UNITED STATES DEPARTMENT OF THE INTERIOR BUREAU OF LAND MANAGEMENT

DEC	10	2010		SU	NDRY	/ NO	TICES	AND	REF	OR	TS .	ON	WEL	LS
			_			_	_		_

SUBMIT IN TRII	PLICATE - Other Instructi	ons on reverse side					
Type of Well X Oil Well Gas Well Gas Well	Other			8. Well Na	me and No.		
 Name of Operator Cimarex Energy Co. of Colorado 		Mallon 34 I	Federal No. 19				
3a. Address		3b. Phone No. (includ	e area code)	30-025-398	394		
600 N. Marienfeld St., Ste. 600;	Midland, TX 79701	432-571-7800		10. Field and	d Pool, or Exploratory Area

Cimarex has changed the SHL of the Mallon 34 Federal No. 19 because the original location at 2055 FNL & 790 FEL was staked over an old pit area. Please see new location and drilling plan below, as well as attached revised plats and preliminary directional survey.

WELL LOCATION AND ACREAGE DEDICATION PLAT

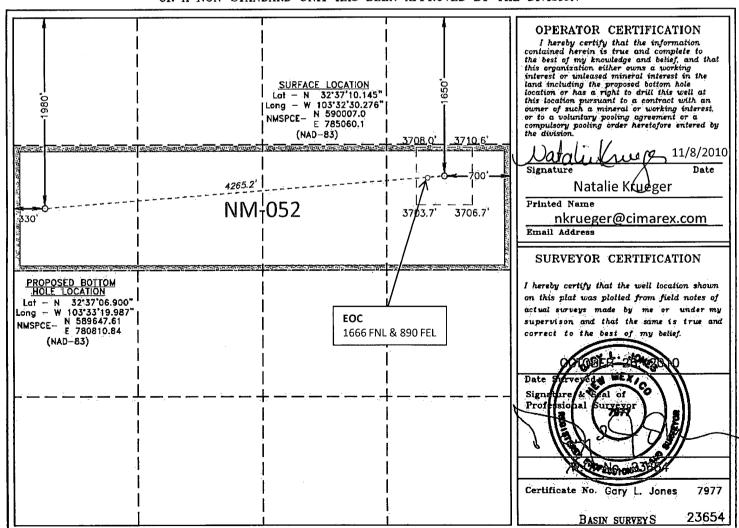
Proposed Location
SHL 1650 FNL & 700 FEL
BHL 1980 FNL & 330 FWL

Instead of drilling a pilot hole and setting 7" casing and fiberglass tubing for kick-off as permitted, Cimarex plans to drill the 8¾" production holeto KOP @ 10749' and through the curve of the lateral to TD @ 15123' MD, 10940' TVD. Run 5½" 17# P-110 LTC casing from 0-TD and cement with Lead 700 sx Econocem + 5# Gilsonite (wt 11.9, yld 2.48) and Tail 1930 sx Halcem (wt 15.6, yld 1.19), TOC 5300 '

Permitted Location SHL 2055 FNL & 790 FEL BHL 1980 FNL & 330 FWL Engineering review is OK. RGH 12/7/2010
